Well Name: PEGASUS 3 FED COM	Well Location: T24S / R32E / SEC 3 / SESE / 32.2410871 / -103.658203	County or Parish/State: LEA / NM
Well Number: 581H	Type of Well: OIL WELL	Allottee or Tribe Name:
Lease Number: NMNM94850	Unit or CA Name:	Unit or CA Number:
US Well Number: 300254725200X1	Well Status: Drilling Well	Operator: EOG RESOURCES INCORPORATED

Type of Submission: Notice of Intent	Type of Action Other
Date Sundry Submitted: 04/12/2021	Time Sundry Submitted: 12:37
Date proposed operation will begin: 04/11/2021	
Procedure Description: EOG respectfully requests an amendment to our approved APD for this well to reflect the following changes: Update hole size and casing program to current design

**Revised Permit Information 4/6/2021:**

## PECOS DISTRICT DRILLING CONDITIONS OF APPROVAL

Revised Wellbore  
API: 30-025-47252

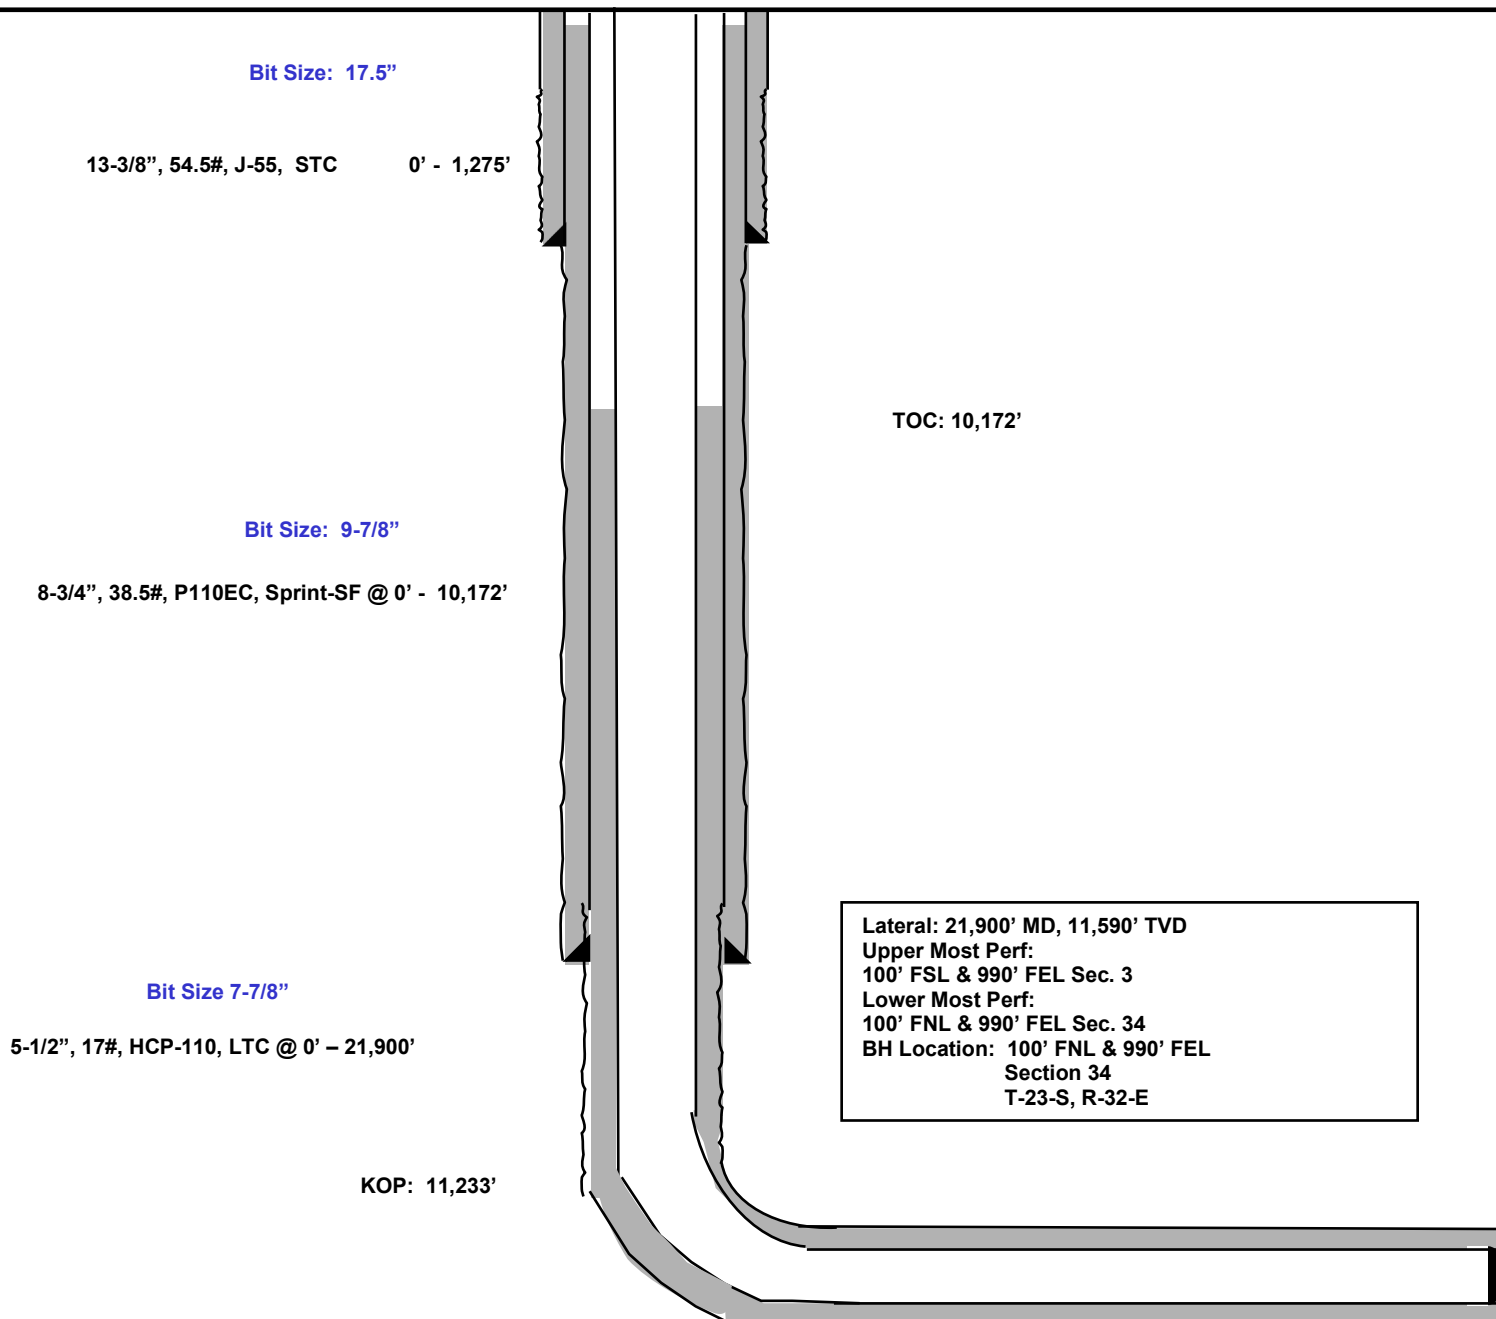
**Casing Program:**

Hole Size	Interval	Csg OD	Weight	Grade	Conn	DF <sub>min</sub> Collapse	DF <sub>min</sub> Burst	DF <sub>min</sub> Tension
17.5"	0' – 1,275'	13.375"	54.5#	J-55	STC	1.125	1.25	1.60
9.875"	0' – 10,672'	8.75"	38.5#	P110EC	Sprint-SF	1.125	1.25	1.60
7.875"	0' – 21,900'	5.5"	17#	HCP-110	LTC	1.125	1.25	1.60

Variance is requested to waive the centralizer requirements for the 8-3/4" casing in the 9-7/8" hole size. An expansion additive will be utilized, in the cement slurry, for the entire length of the 9-7/8" hole interval to maximize cement bond and zonal isolation.

Variance is also requested to waive any centralizer requirements for the 5-1/2" casing in the 7-7/8" hole size. An expansion additive will be utilized, in the cement slurry, for the entire length of the 7-7/8" hole interval to maximize cement bond and zonal isolation.
